Re: Strata Energy, Inc., Ross In-Situ Recovery Project  
Source Materials License SUA-1601, Docket No. 040-09091  
Request for Additional Information, LC 9.5, 2018 Annual Revised Financial Assurance Estimate

## **RAI 1**

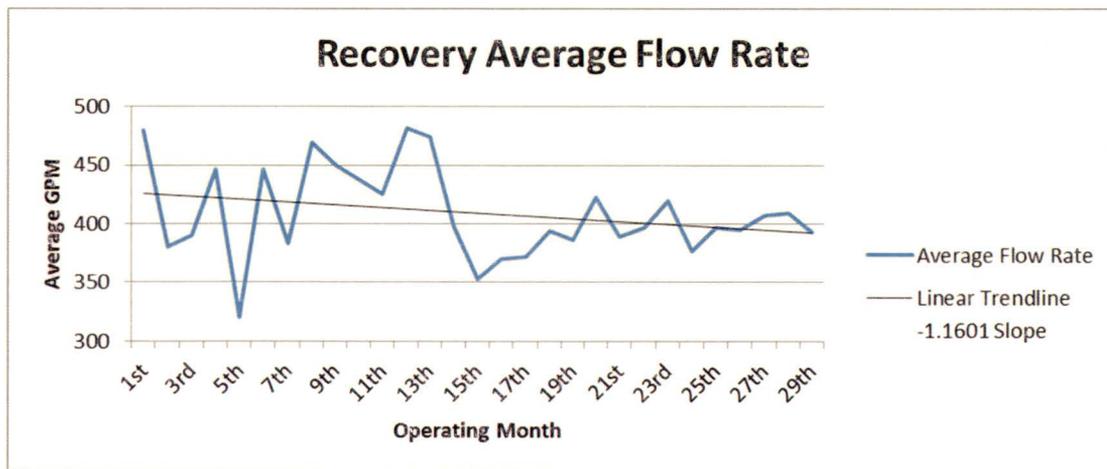
The pore volume calculations in the 2018 surety update (Strata, 2017a) use a flare factor of 1.44 “[b]ased on groundwater modeling of expected operational conditions and horizontal flare factors applied at other [in situ recovery] ISR facilities (e.g., Lost Creek, Nichols Ranch, and Christensen Ranch)”. However, in the reclamation plan approved for the licensing of the Ross ISR Project, numeric modeling results for licensing the Ross ISR Project, and the most recent surety updates (e.g., Strata, 2015, 2016a), Strata stated that a flare factor of 1.58 is applicable to the Ross ISR Project. The licensee did not provide justification for revising the flare factor other than it is “applied at other ISR facilities.”

Please provide a detailed basis for the adjustment in flare factor. Alternatively, please revise the surety calculations to use the previously approved flare factor of 1.58 for the Ross ISR Project.

In preparing the 2018 surety update, Strata evaluated the impact of site-specific injection and recovery flow rates, well placement and wellfield geometry in Mine Units 1 and 2. The results of this evaluation support the lower flare factor of 1.44. These aspects were identified in the numeric modeling provided with the license application as the most sensitive inputs<sup>1</sup>. As required in Appendix A, Criterion 9, Strata

considered these design and operational aspects for the two specific mine units covered by the surety rather than a representative mine unit that was postulated during the licensing process, which resulted in changes to the flare factor and, ultimately, in restoration costs.
